CITY OF SAINT LOUIS

ADDENDUM NO. 1

UNION/LINDELL BRIDGE REPLACEMENT

DATE: **10/7/26**

Sheet SW-02 & Sheet NW-02

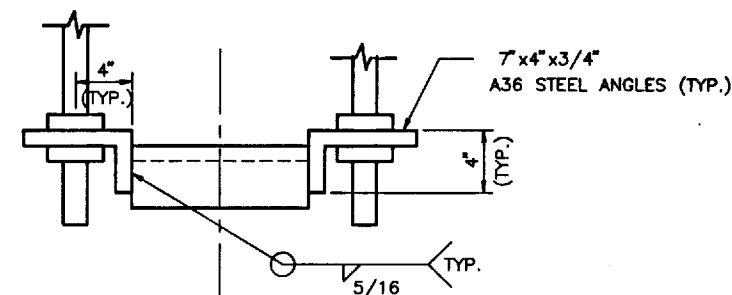
Revise the last general note to say the following: "The Contractor shall be responsible for the internal and external stability of the MSE wall structure, including compound stability. The Engineer of Record shall be responsible for the overall global stability of the MSE wall structure."

CATENARY POLE FOUNDATION DETAILS TYPE II

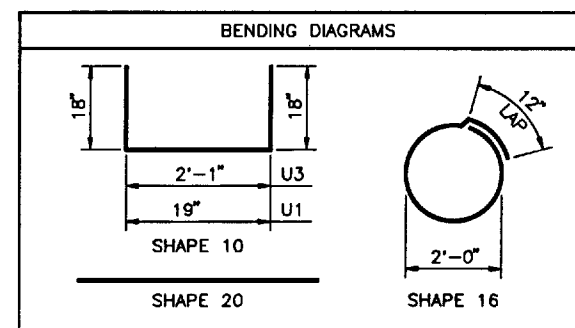
Section 4.0 Construction Requirements: Revise the second sentence to say the following: "Contractor to reference as-built drawings attached to Addendum #1 for details related to proposed foundations and anchor bolts."
